# Rezoning Transportation Analysis

Petition Number: 2023-034

Date	Description
06-28-23	First Review (TM)
07-28-23	Second Review (TM)
08-21-23	Trip Gen. Update (TP)
10-26-23	Third Review (TM)

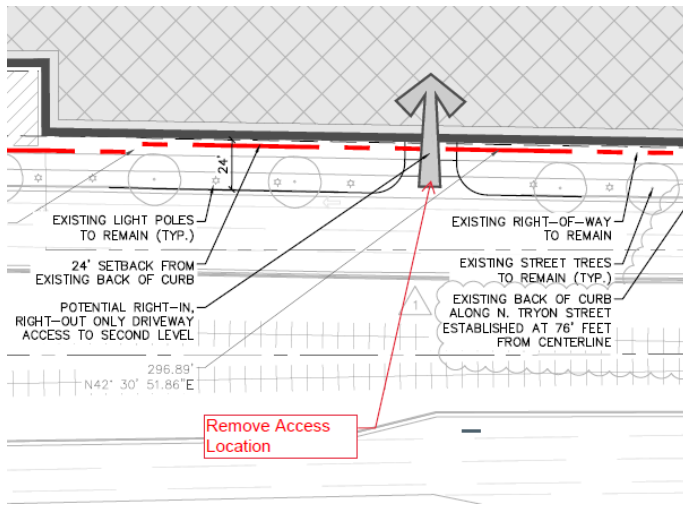
3. **NEW COMMENT FROM 10-26-23:** Remove Access point that was added to Tryon Street.
